Product Change Notice for HOLLAND FWAL Aluminum Fifth Wheel Service Parts

This product change notice impacts service parts for HOLLAND aluminum fifth wheel assemblies (FWAL) and top plates (XA-AL).

Effective with shipments April 2013

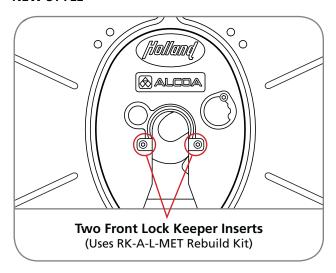
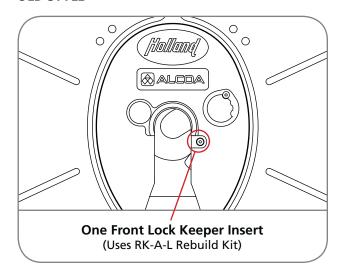
- 1. An additional keeper insert has been designed into the top plate for better wear resistance.
- 2. Fasteners have been converted to metric for commonality.
- 3. A new shim ring was added to help with the fit of the adjustment pin (Item No. 36).

A new rebuild kit has been created for the new style top plate (RK-A-L-MET). You can visually identify the difference between the new style and old style top plates be determining the number of keeper inserts. If the fifth wheel has two keeper inserts, it is the new style and it requires kit number RK-A-L-MET. If the fifth wheel only has one keeper insert, it is the old style and it requires kit number RK-A-L. Please see the 'NEW STYLE' and 'OLD STYLE' figures on right for a visual representation of the change.

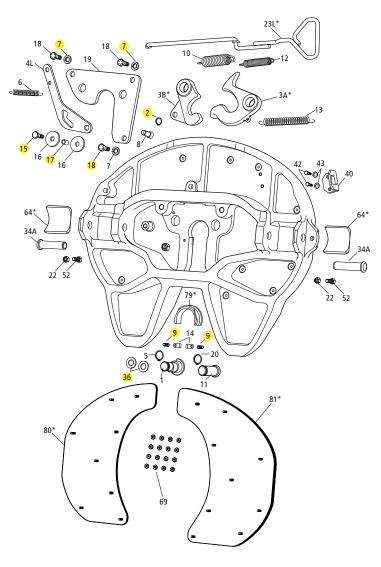
Note: The highlighted parts are for the new style design.
